## DETERMINATION OF NON-SIGNIFICANCE

**City of Bellevue  
Development Services Department  
Land Use Staff Report**

Proposal Name: **Pacific Regent II**

File Number: **10-117762 -LD**

36' Diameter turntable

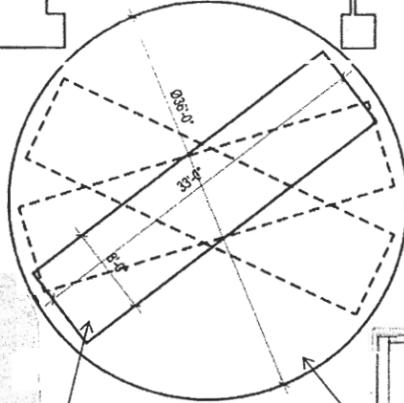
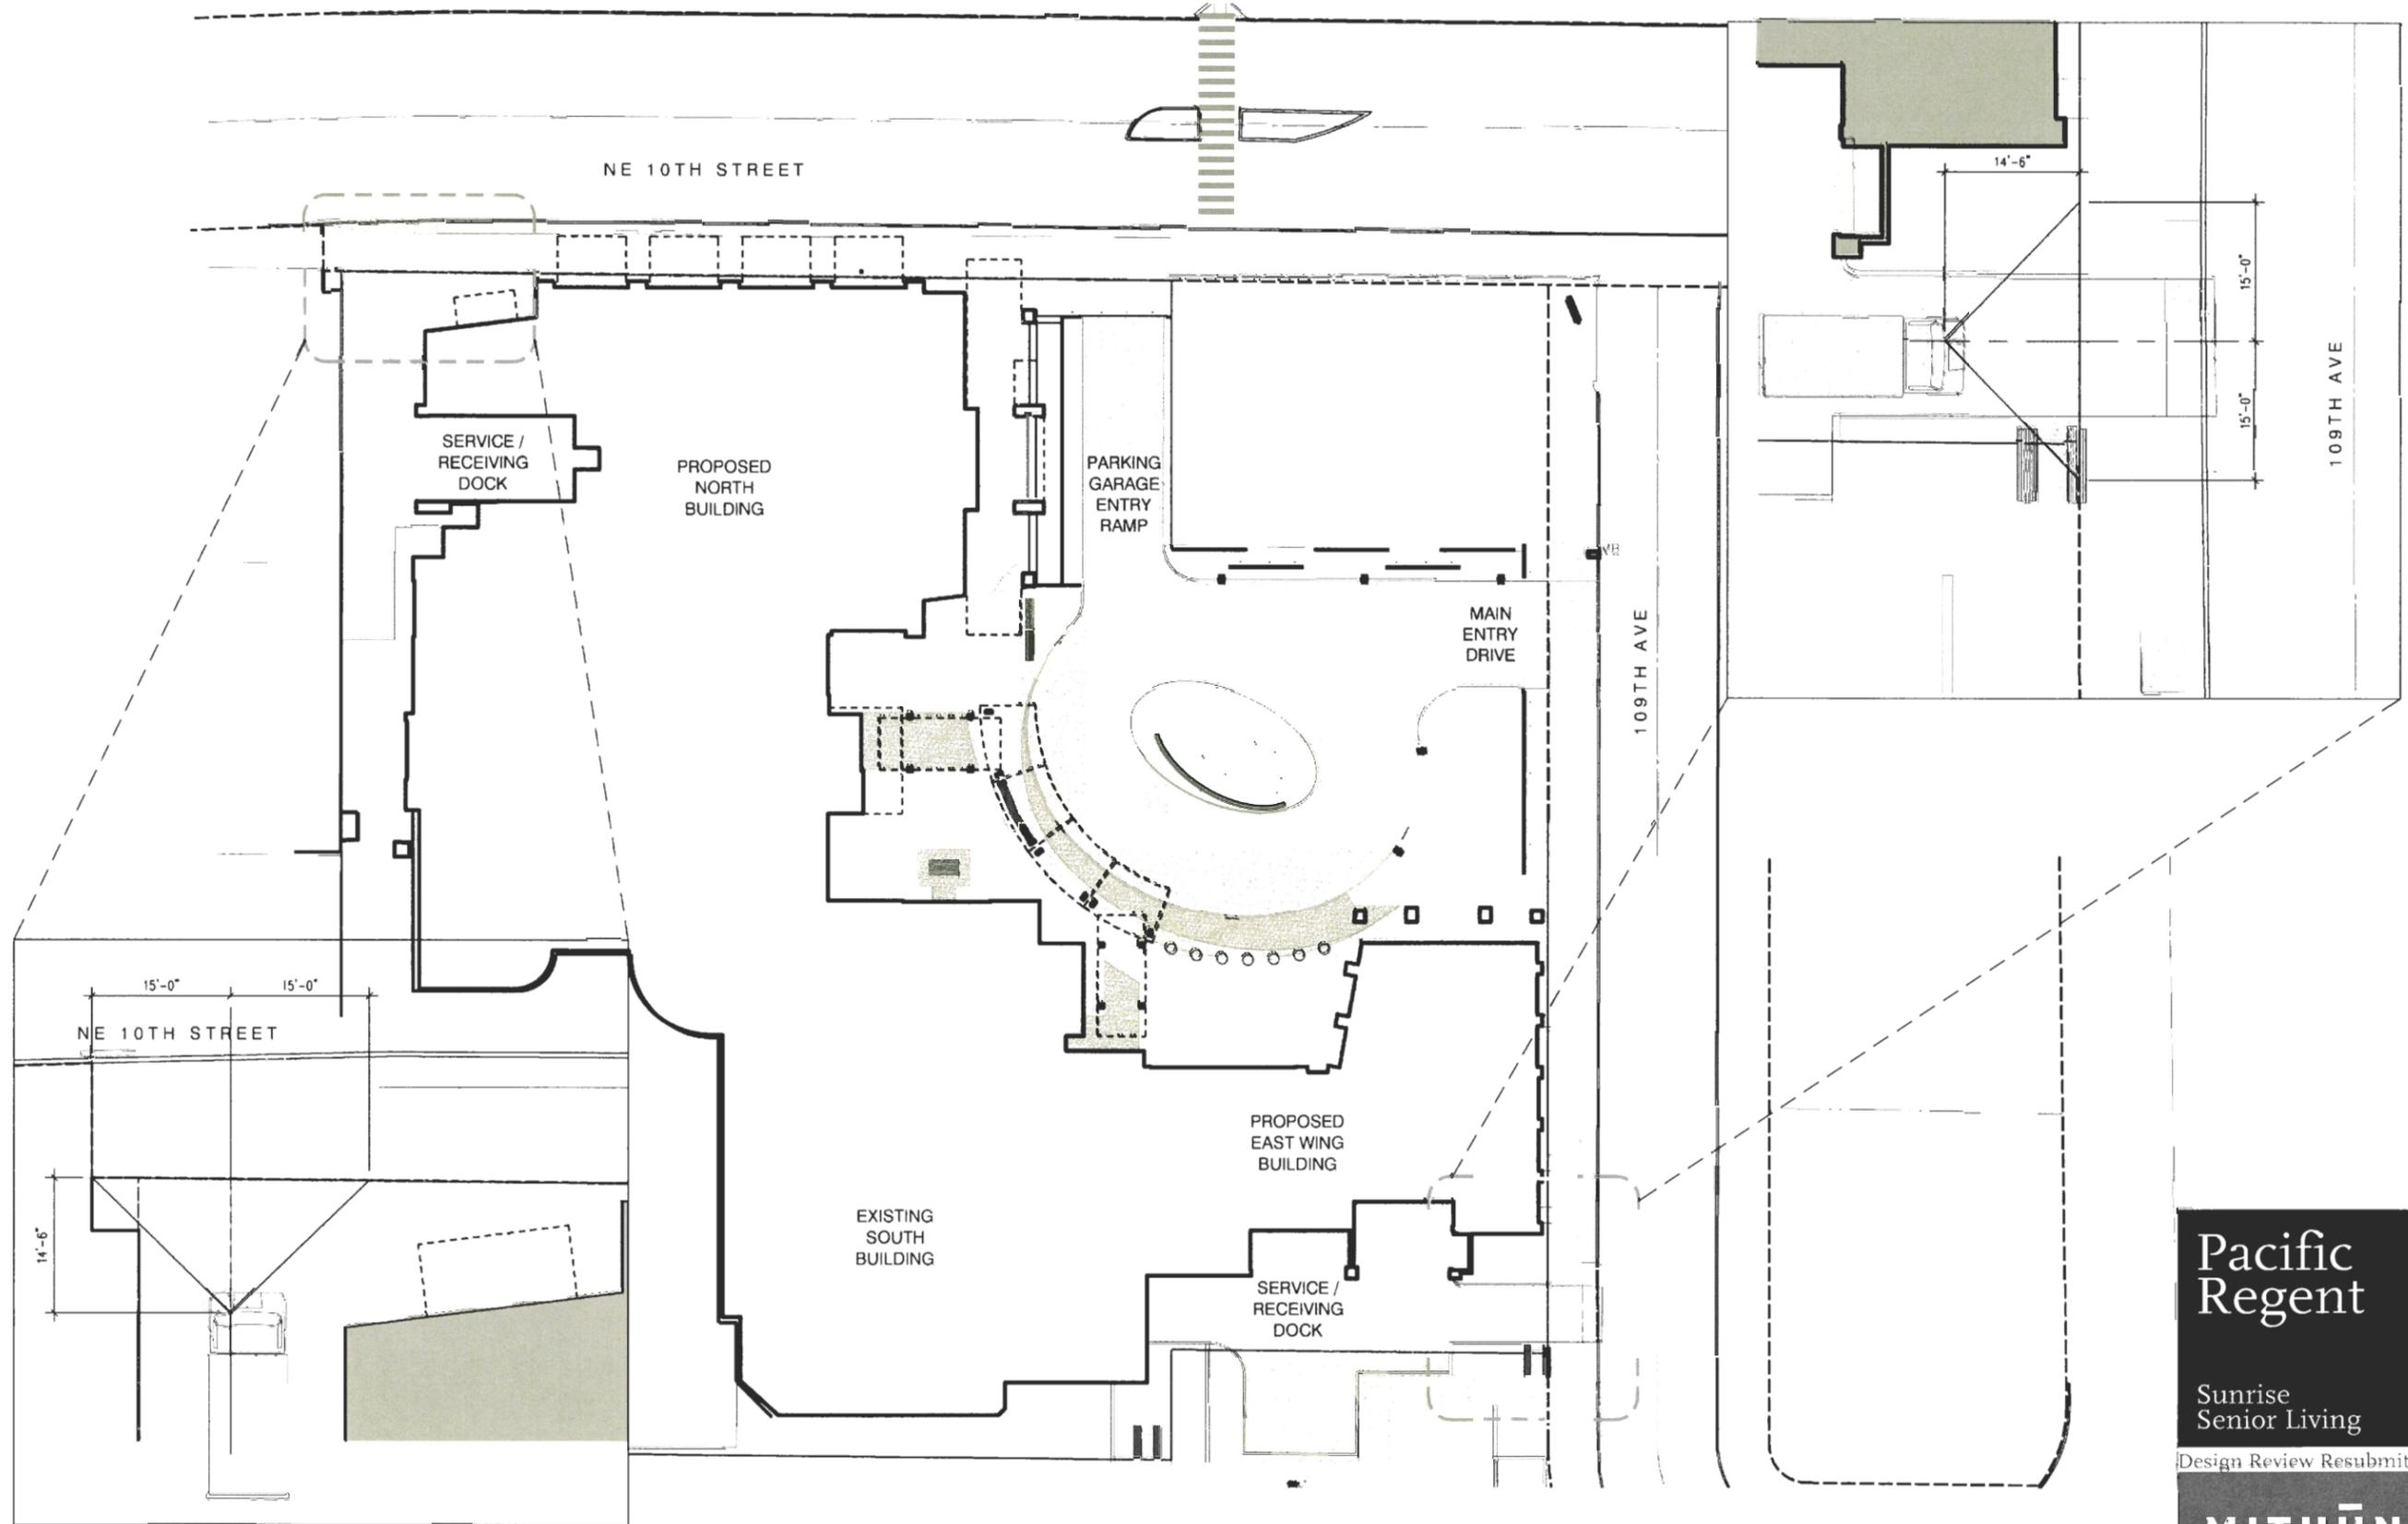
There is not sufficient maneuvering room in the proposed refuse/recycling area for waste hauling vehicles to serve the area without backing across the public sidewalk (along 109<sup>th</sup> PI. NE). Backing movements would increase the potential for conflicts between refuse vehicles and pedestrians, as well as other vehicles. The proposal was revised to include a motor-driven turntable capable of rotating the hauler's vehicles (up to 33-feet in length), thus eliminating the need to back across the public sidewalk.

The proposed turnstile shall be capable of rotating the refuse hauler's vehicles so that the drivers can enter the site or exit the site without backing across the public sidewalk. The turnstile manufacturer shall provide written documentation supported by engineering specifications that the proposed turnstile size, design and construction is fully capable of rotating Allied Waste's trucks when loaded to full capacity. The applicant shall provide further proof in the form of an agreement with Allied Waste that it will use the turnstiles to eliminate backing their vehicles across the public sidewalk. The developer must implement procedures to ensure that the service driveway from 109<sup>th</sup> Avenue NE will only be used by refuse trucks capable of being turned around using the turnstile. Regarding the service access driveway off NE 10<sup>th</sup> Street, it shall
